Planning Commission Application

FORT GRATIOT PLANNING COMMISSION SITE PLAN REPORT

RE: Smart Storage Solutions - Mini Storage Site Plan, 3134 Keewahdin Road, Fort Gratiot Township (Plan Review No. 01)

SITE PLAN
SMART STORAGE SOLUTIONS
3134 KEEWAHDIN ROAD, FORT GRATIOT, MI 48059

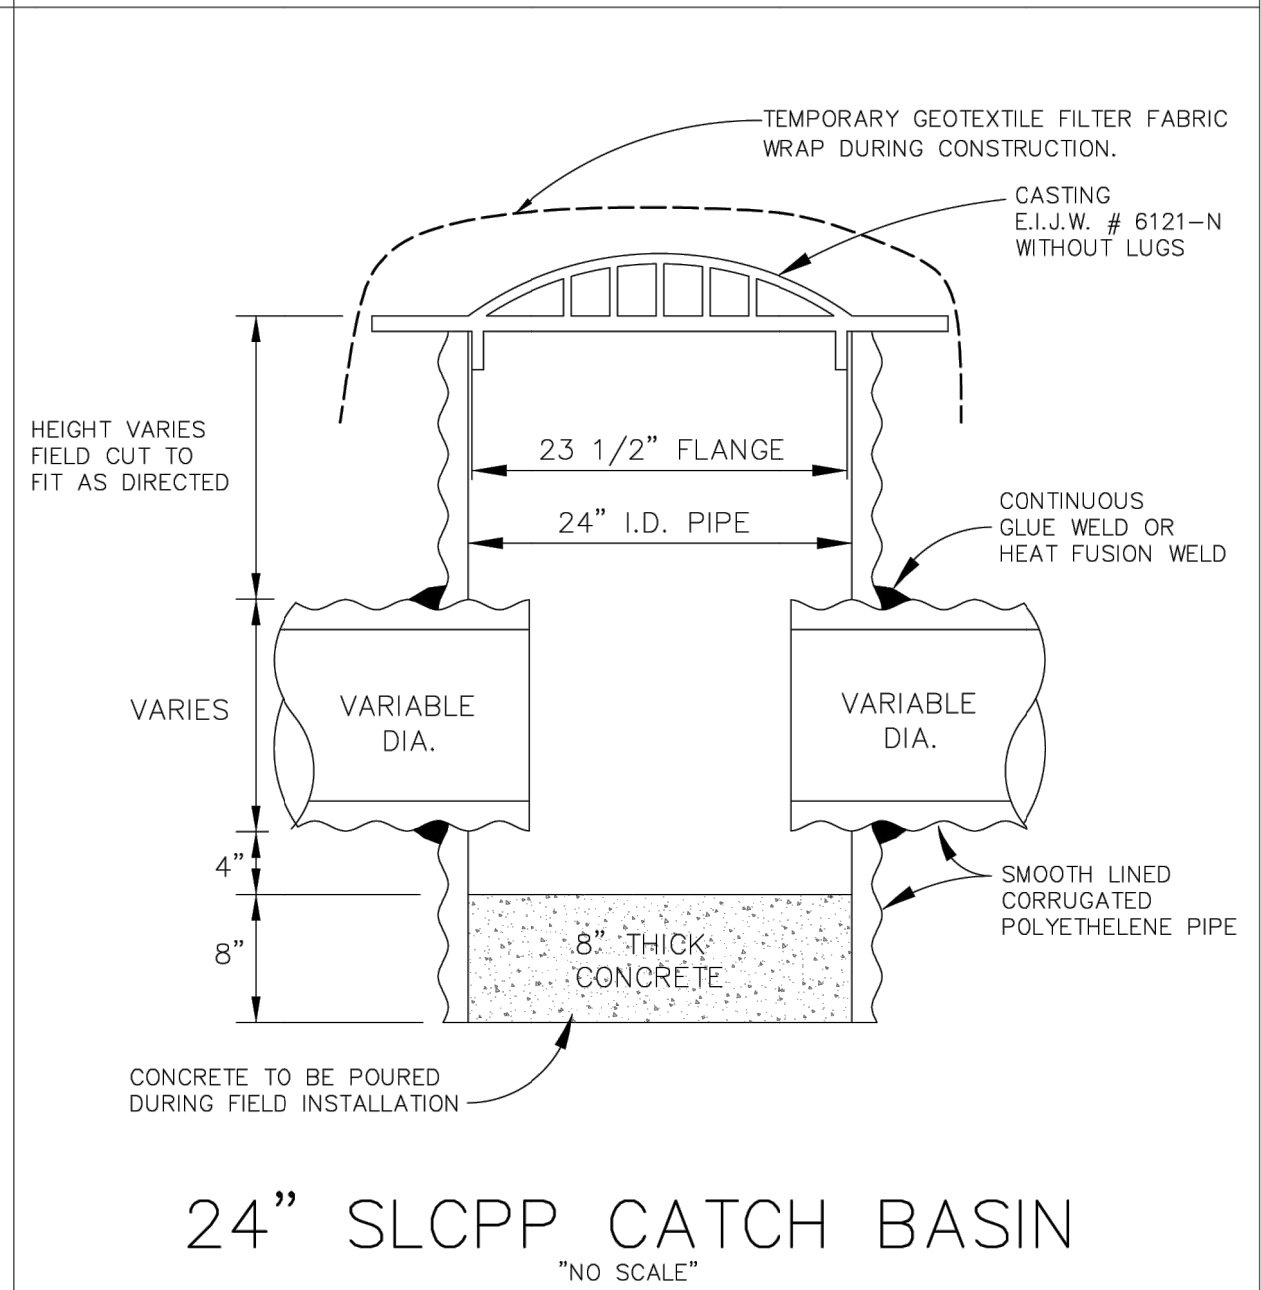
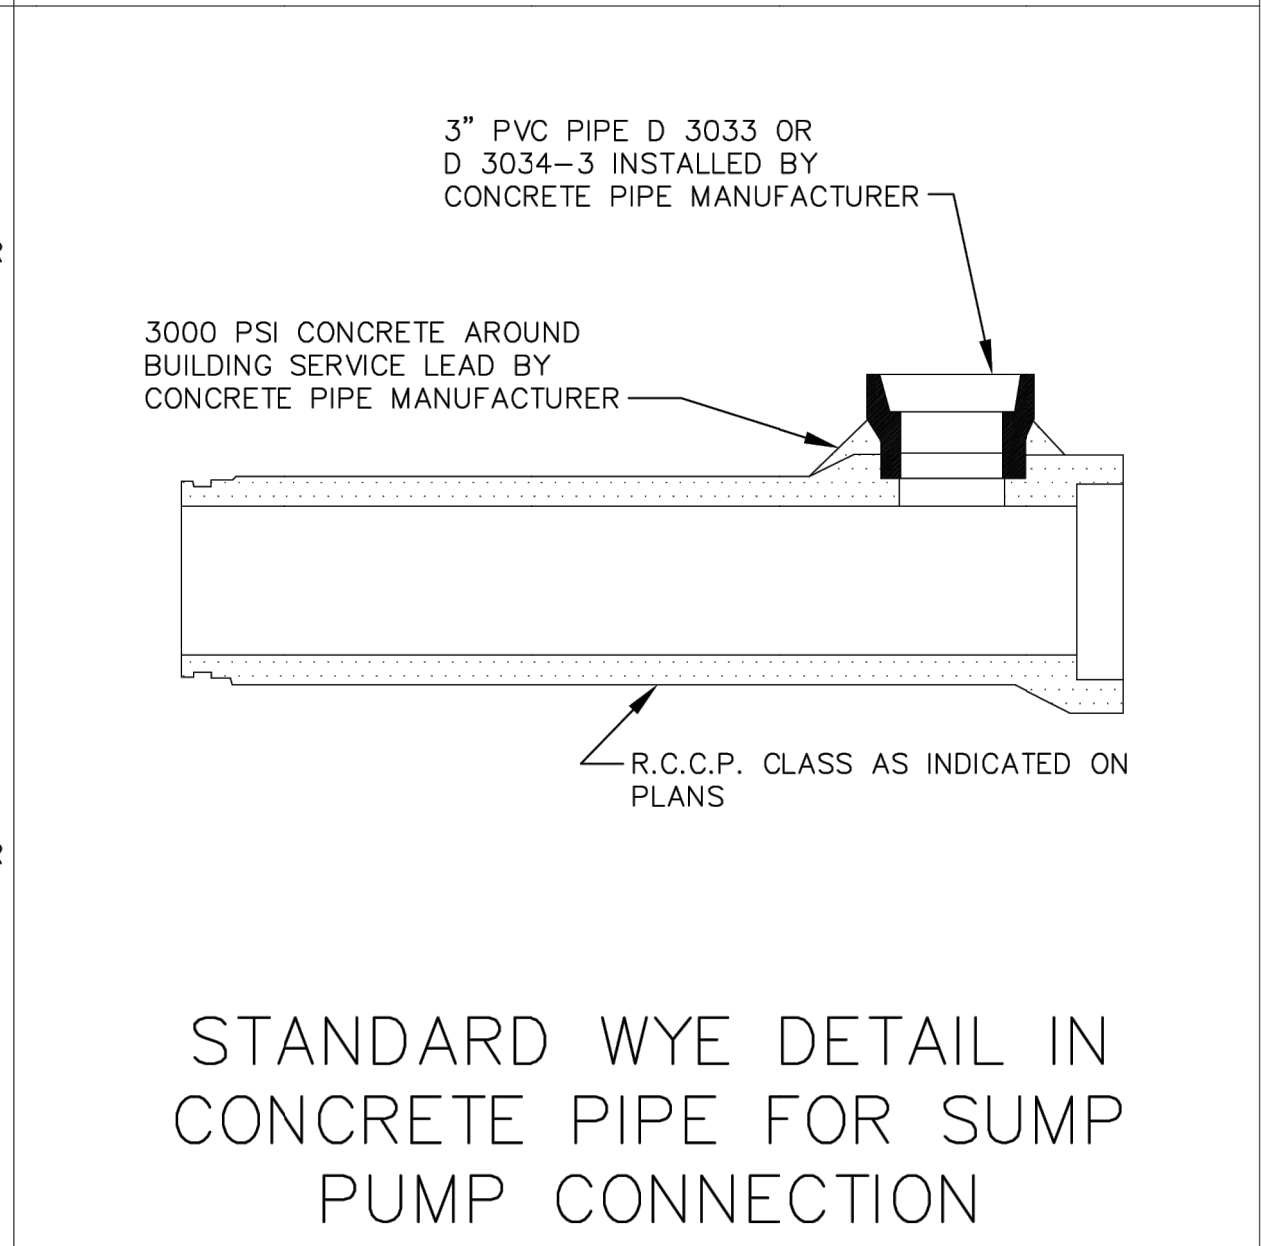
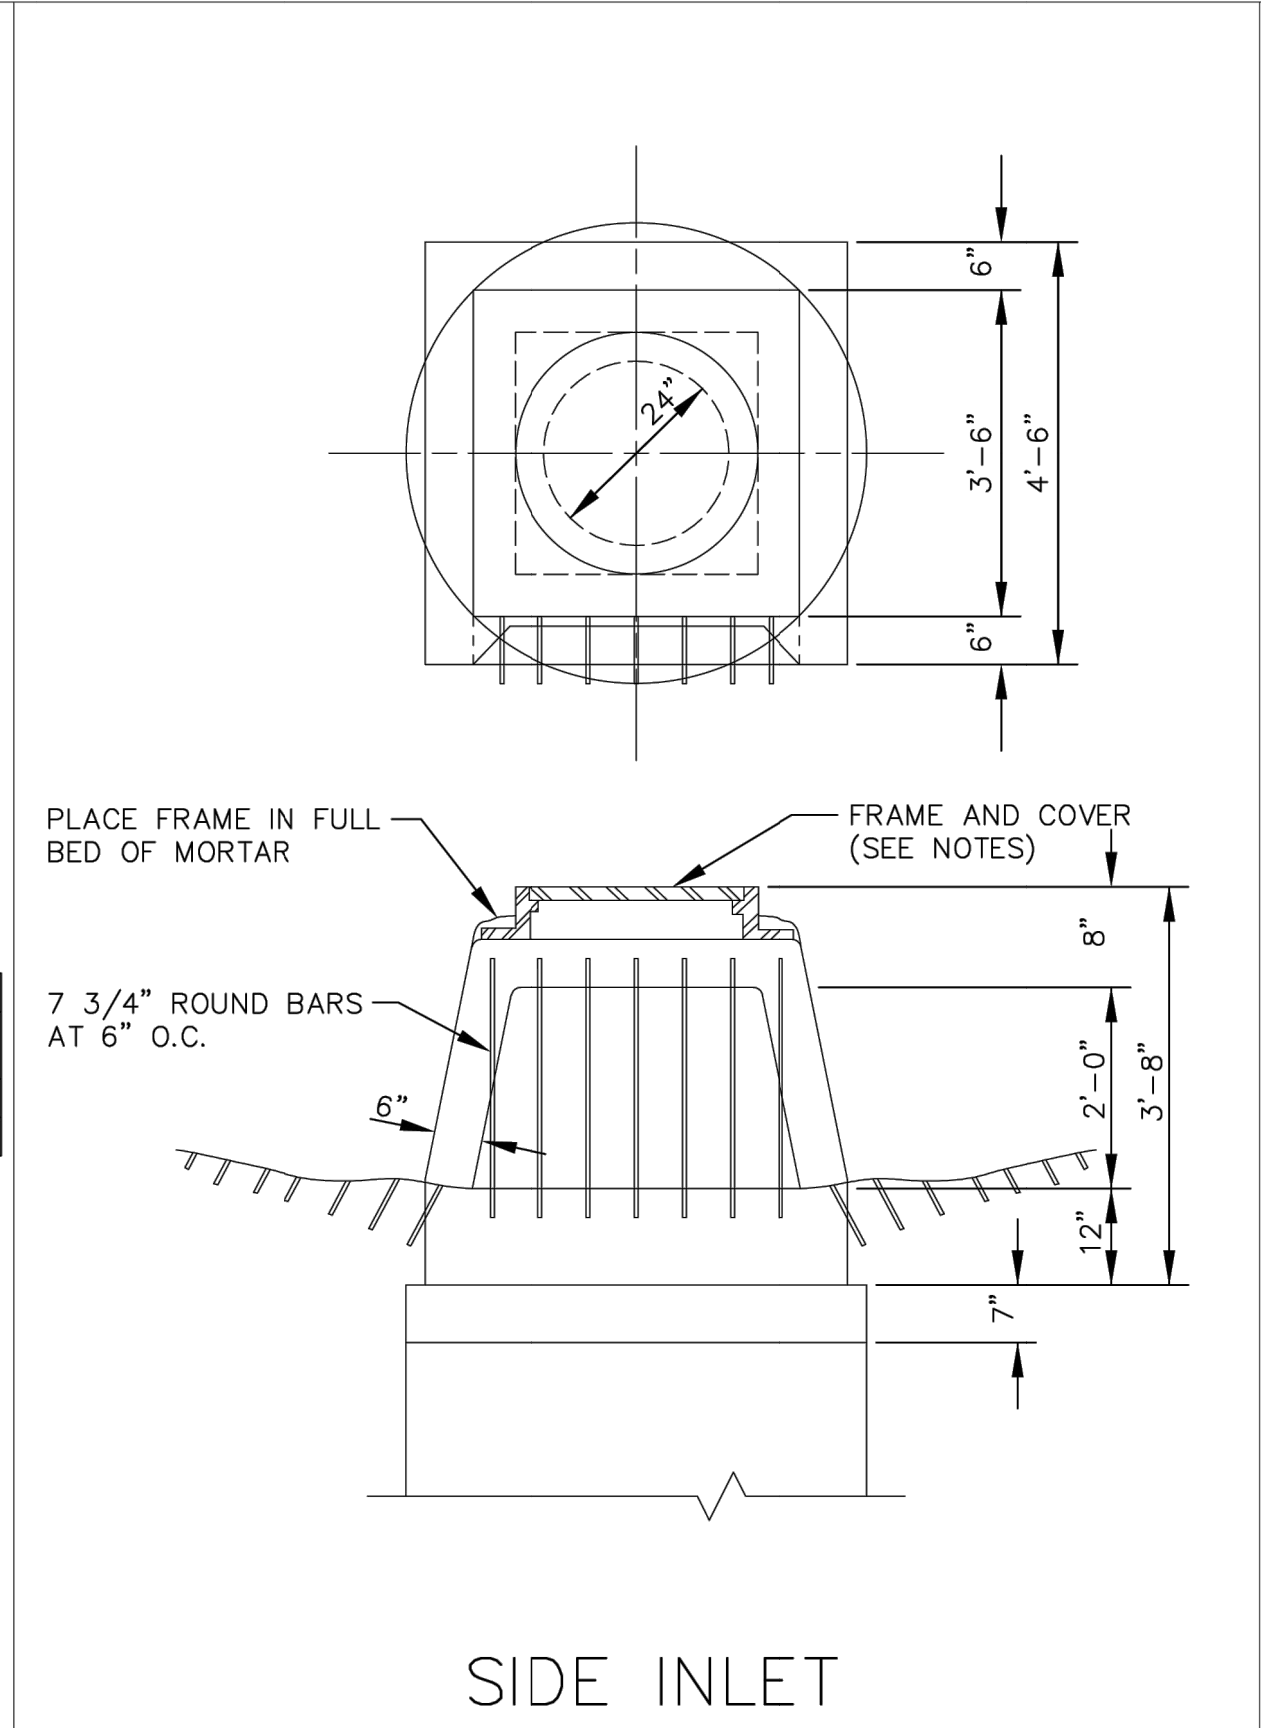
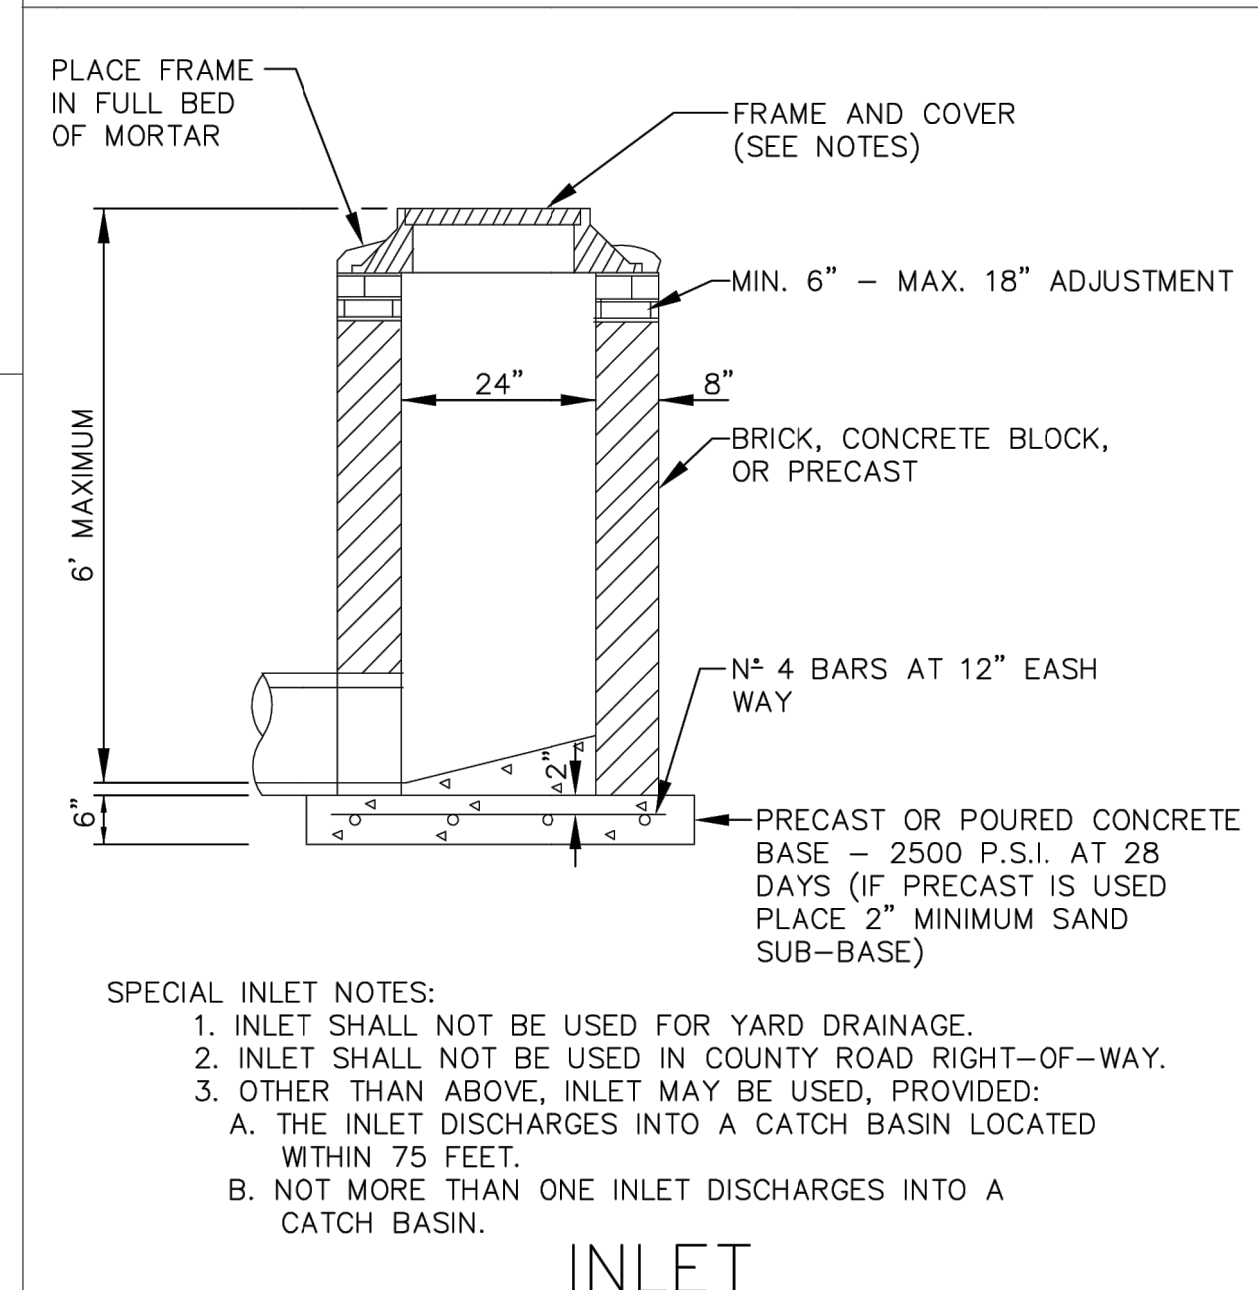
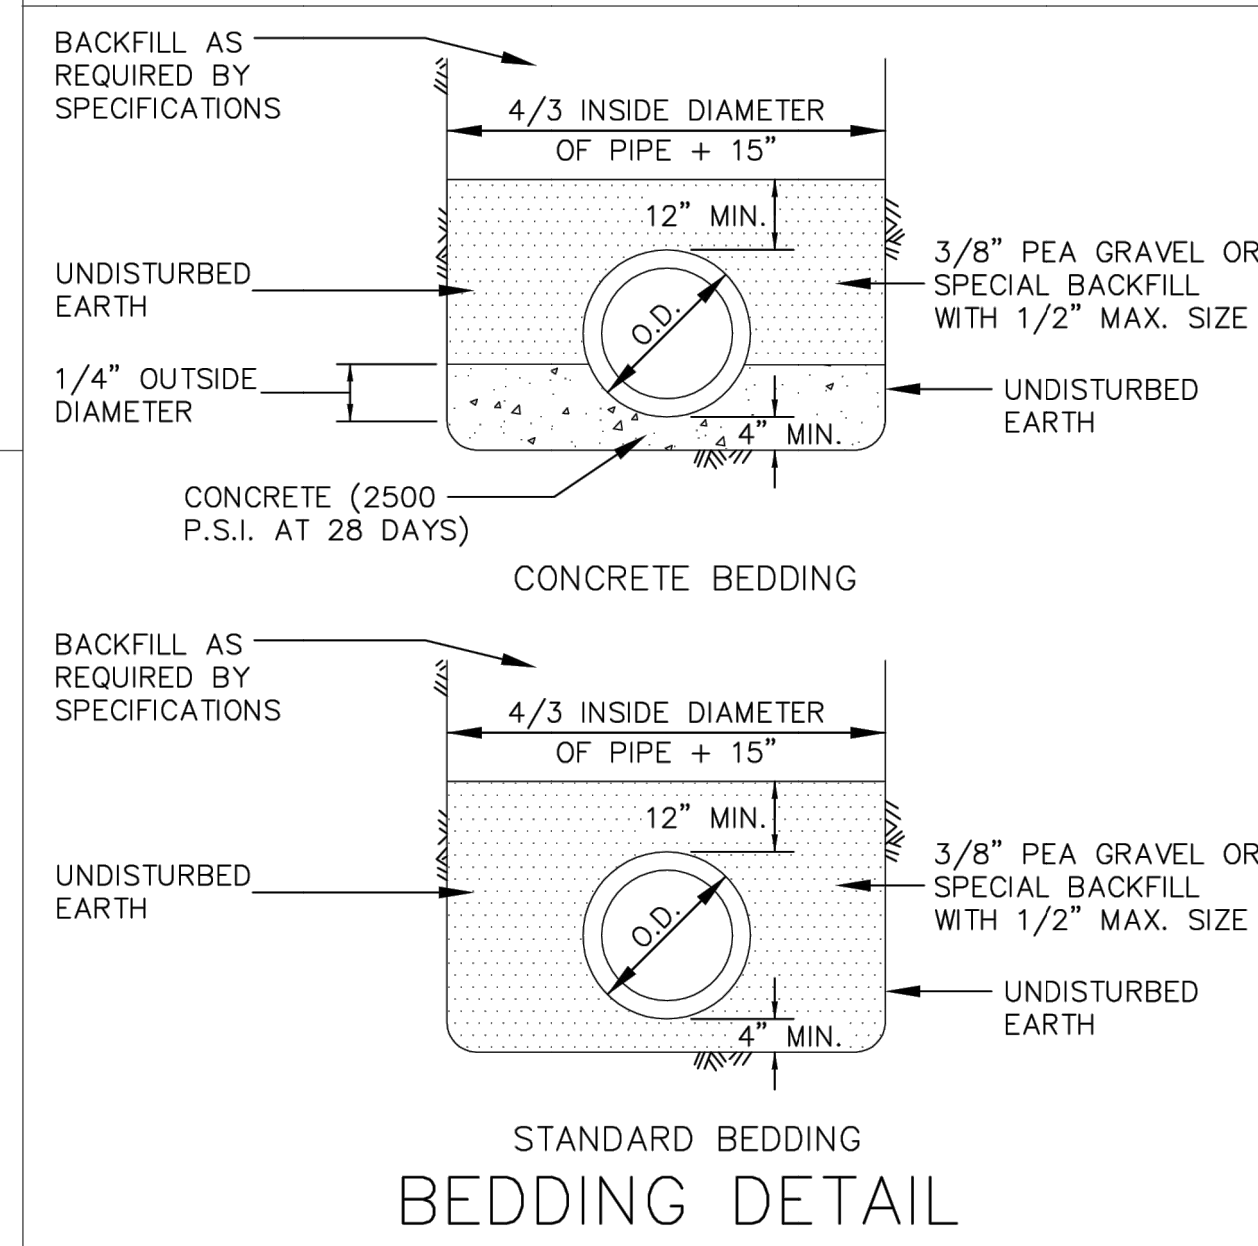
5. The Permanent Detention Basin Outlet Filter Detail on Sheet 5 indicates eight 1-inch outlet holes are to be provided at elevation 601.00 for the 100-year outlet. These holes are not shown in the detail drawing and should be provided.
